ACCESS REPORT
DEVELOPMENT APPLICATION
26-28 SHEPHERD STREET
LIVERPOOL
MULTI-UNIT RESIDENTIAL DEVELOPMENT

The purpose of this report is to provide an accessibility review of a Development Application for a multi-unit housing development on a site at 26-28 Shepherd Street, Liverpool.

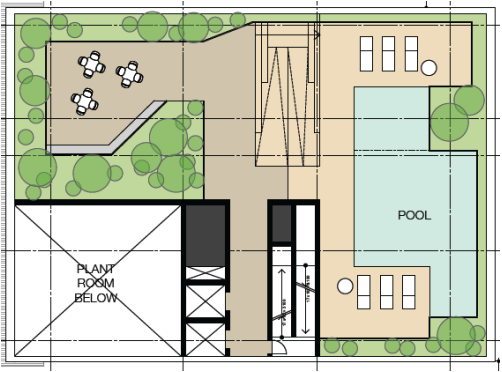
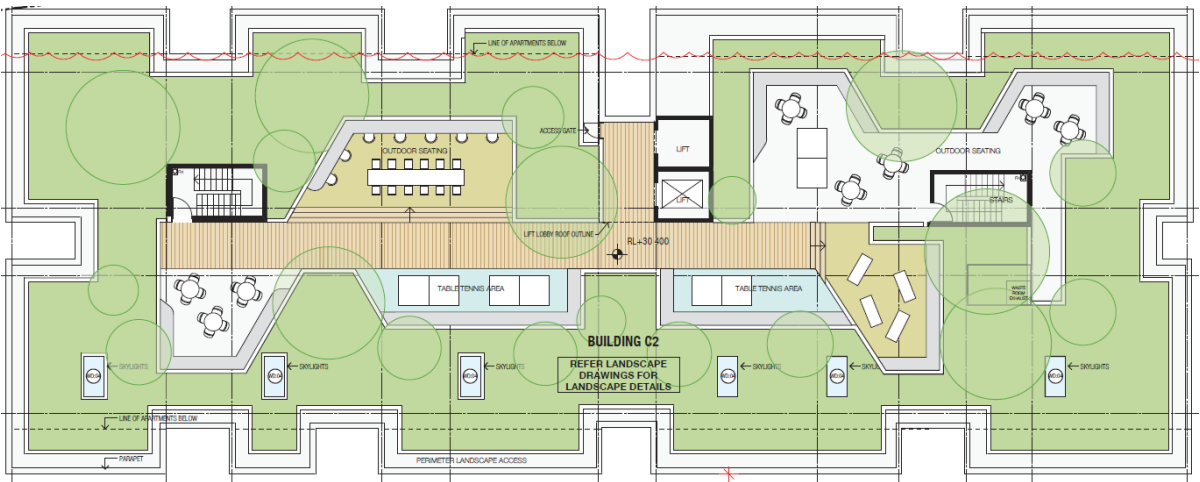
BCA / DDA Access Code Review	Complies
<p>1. The development forms Stage 2 of the “Paper Mills” project and proposes on-grade accessways from the Shepherd Street public domain footpath to a common lobby entrance of Building B (No 26 Shepherd St) and Building C2 (No 28 Shepherd St), which enables direct access to a central plaza to access Building C1.</p> <p>2. The public riverside walkway shall provide an accessible entry to the site that enables a wheelchair accessible path of travel to Shepherd Street.</p>	<p>YES</p> <p>YES</p>

<p>3. Building B (26 Shepherd St) - The Shepherd Street entry pathway shall provide a 1:20 maximum gradient walkway approach from the public footpath @RL10.620 to lobby doorways with a level landing and level threshold to enter the lobbies @RL10.900 which contains two lifts that travel to other levels and through access to a central landscaped plaza area.</p> <p>4. The entry lobbies include auto sliding doors and provide ample circulation spaces and direct access to the central plaza.</p>	<p>YES</p> <p>YES</p>
<p>5. Building C2 (28 Shepherd St) - The Shepherd Street entry pathway shall provide a 1:20 maximum gradient walkway approach from the public footpath @RL11.690 to lobby doorway with a level landing and level threshold to enter the lobby @RL11.800 which contains two lifts that travel to other levels and through access to a central landscaped plaza area.</p>	<p>YES</p>

BCA / DDA Access Code Review	Complies
6. The 5500mm minimum width entry lobby and auto sliding doors provide ample circulation spaces and direct access to the central plaza which proposes access to Building C1.	YES

7. The 1800mm width ground floor common corridor proposes a single floor level and enables an accessible path of travel to every ground floor unit to satisfy Table D3.1 of the BCA.	YES

8. Building C1 (Riverside) - The central plaza shall provide a 1:40 maximum gradient walkway between the two buildings with the lobby doorways incorporating level landings and level thresholds to enter the lobbies @RL11.800.	YES

9. The plan illustrates a moderately graded 1:40 to 1:24 accessible pathway link from the public domain Shepherd Street footpath from RL12.180 to Riverside public domain riverside walkway from RL9.910.	YES

10. The riverside frontage also proposes a stairway to the principal lobby which will be detailed at a future design stage to accommodate handrails and tactile indicators and stairway nosings in accordance with AS1428.1 and AS1428.4.1 to satisfy Parts D3.3 and D3.8 of the BCA.	YES at CC stage

11. Building C1 provides a single level within the ground floor with appropriate access paths to all ground floor apartments to satisfy Table D3.1 of the BCA.	YES

12. Details regarding door sizes, door hardware, level thresholds, doorway luminance contrast and accessible intercom controls shall be documented at the construction certificate stage in accordance with AS1428.1 to satisfy Parts D3.2 and D3.3 of the BCA.	YES at CC stage

Swimming Pools (Part D3.9 of the BCA)

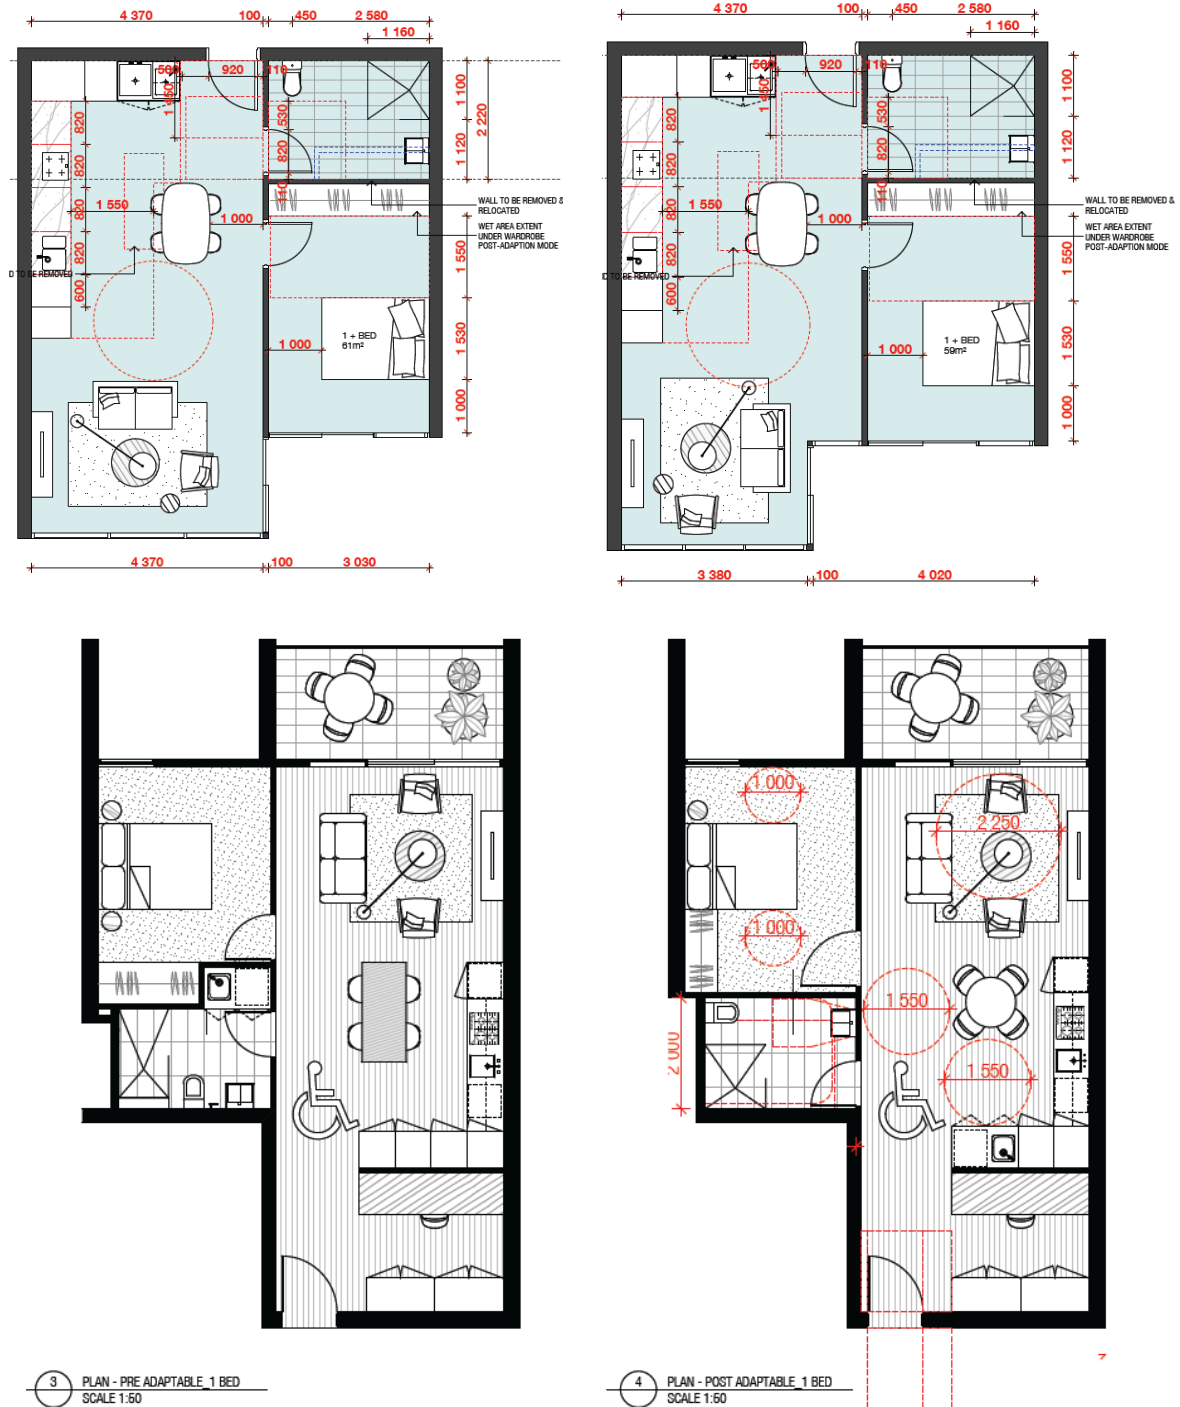
BCA / DCP Access Review	Complies
46. The pool indicates a 40 metre perimeter and will include a pool hoist to comply with D3.10 of the BCA.	YES at CC stage

Part B - Adaptability Assessment

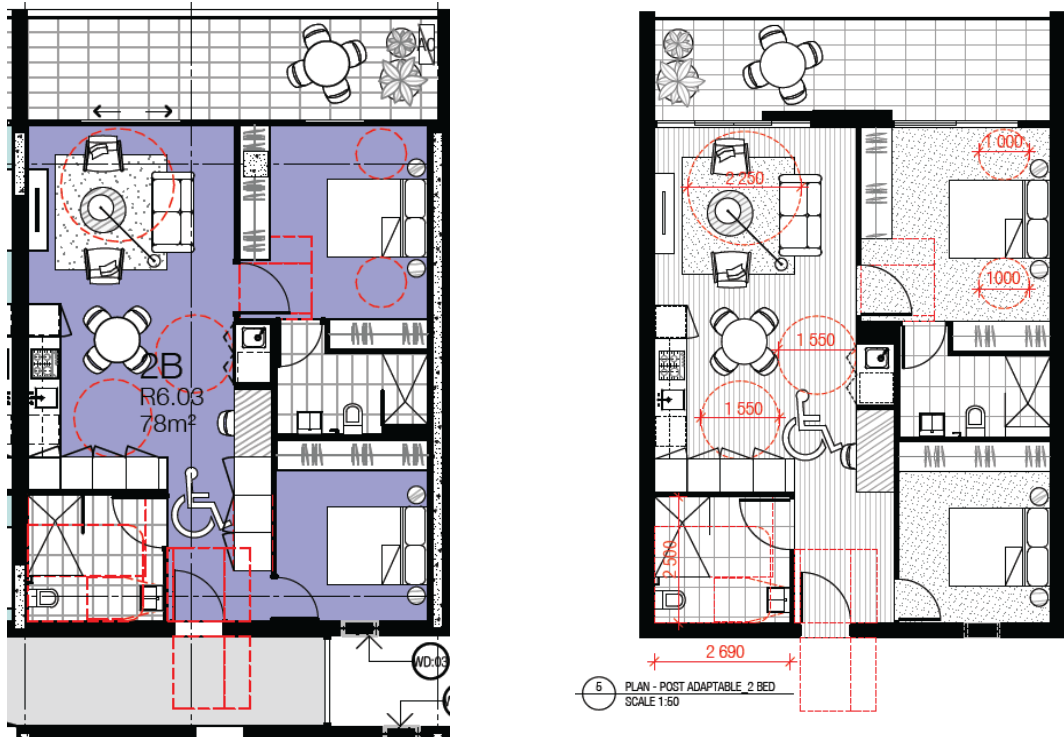
Clause	Adaptability Assessment	Compliance
AS4299 Cls 3.3 and 3.5	<p>Common Resident Site Access & Entry Lobbies – Part A of this report confirms that the development will provide accessible lobby entrances and continuous accessible paths of travel to enter the lifts and ensure equitable access in accordance with AS1428.1 to satisfy Parts D3.2/D3.3 of the BCA and Council’s DCP.</p> <p>Overall I am satisfied that the principal site and building entrances and access to the lifts and common corridor accessways will provide appropriate access for people with disabilities in accordance with AS1428.1 / AS4299.</p>	YES
AS4299 Cls 3.7	<p>Resident Car Parking</p> <p>The car park provides thirty-eight (38) accessible resident parking spaces of;</p> <ul style="list-style-type: none"> • 2400mm width that adjoin a 2400mm width shared area to comply with AS2890.6 and be consistent with AS4299; OR • 3200mm width which adjoin a driveway to facilitate the required shared area access space consistent with the intent of AS2890.6 and AS4299. <p>The car spaces will be graded at a 1:40 maximum slope and crossfall in accordance with AS2890 with an accessible path of travel to the lifts.</p> <p>The car parking provides 2200mm minimum entry height clearance and 2500mm height over the designated accessible parking spaces in accordance with AS4299.</p>	YES

AS4299 Clauses 4.3.1, 4.3.2 and 4.3.3	<p>Accessible entries – The front entrances to the adaptable units provide at least 1600mm X 1600mm externally with 530mm minimum latch side clearance, which complies with the spatial requirements of AS4299. The internal foyer areas can also provide 530mm minimum latch side clearance to comply with the spatial requirements of AS4299 by adapting the fridge location within the kitchen.</p>	YES

Clause	Adaptability Assessment	Compliance
	Interior: general – With regard to the internal corridors and doorway approaches to a <u>main bedroom</u> , adaptable bathroom and laundry the post adaption of an adjacent stud wall or sliding door conversion to swing doors will enable complying the doorway circulation spaces to satisfy AS1428/4299.	YES
AS4299 Cls 4.3.7	Doors and Door Hardware The plans will confirm 920mm external door widths, 870mm internal door widths and lever handles at construction drawing stage to confirm compliance.	YES
AS4299 Clause 4.7	Living and Dining rooms – The plans show combined living and dining areas on a single level with sufficient area to provide a 2250mm diameter turning area to comply with this clause.	YES
AS4299 Clause 4.5	Kitchen – The single galley kitchens provide the required 1550mm minimum circulation space adjacent to the benches and appliances to comply with AS4299 requirements. The double galley kitchens with the free standing island bench can be readily adapted to achieve 1550mm clearance to comply with AS4299. With regard to the “adaptability” of the kitchen the construction drawings shall provide details of an appropriate layout of sink, fridge, wall oven, cooktop and height adjustable workbench that readily satisfies the “ease of adaptation” guidelines outlined in section 2 – Performance Objectives of AS4299. Therefore, subject to confirmation of the installation of kitchen cupboards, appliances and the like at the construction documentation stage it is evident that the kitchens will comply with AS4299.	YES YES YES

AS4299 Clause 4.6	Main bedroom – The plans show a main bedroom for the adaptable Units will allow a circulation area of 1540mm X 2070mm clear of a queen sized bed while maintaining 1000-1200mm clearance on the side and 1000-1200mm at the foot of the bed and clear of the wardrobe to satisfy AS4299. The rooms shall have a minimum area of; <ul style="list-style-type: none"> • 1 bedroom type - 4100mm-5800mm X 3000mm clear of the robe when adapted. • 2 bedroom type - 3700mm X 3550mm clear of the robe when adapted. • 3 bedroom type - 4200mm X 3000mm clear of the robe. There are several options to adapt the wardrobe location to enhance internal bedroom access to comply with AS4299.	YES YES YES YES
AS4299 Clause 4.7	Bathroom – The plans show that the bathrooms for each apartment will be at least 2000mm X 3000-3300mm or 2400mm X 2650mm with a post adaptation modification to; <ul style="list-style-type: none"> • Remove the shower screen and relocate the toilet pan which enables compliance with AS1428 in terms of spatial area setout. 	YES YES

Clause	Adaptability Assessment	Compliance
	<ul style="list-style-type: none"> Modify the vanity to a wall basin which enables compliance with AS1428 in terms of spatial area setout. 	YES
AS4299 Cls 4.4.3	Toilet – The toilet within the bathroom shall comply with AS4299 by providing 1250mm X 900mm in front of the WC pan.	YES
AS4299 Clause 4.8	Laundry – The laundry facilities are provided in a closet, which enables 1550mm X 1550mm clear circulation space in front of the appliances to comply with AS4299.	YES
AS4299 Cls 3.5(b)	<p>Outdoor Private Open Space – The plans show outdoor terrace areas adjacent to living areas with sliding doors.</p> <p>The areas provide adequate space to perform a 180 degree wheelchair manoeuvre.</p> <p>While the plans do not indicate thresholds the construction drawings will confirm a 35mm maximum change in level with the capability for threshold ramps to comply with AS1428/4299.</p>	YES
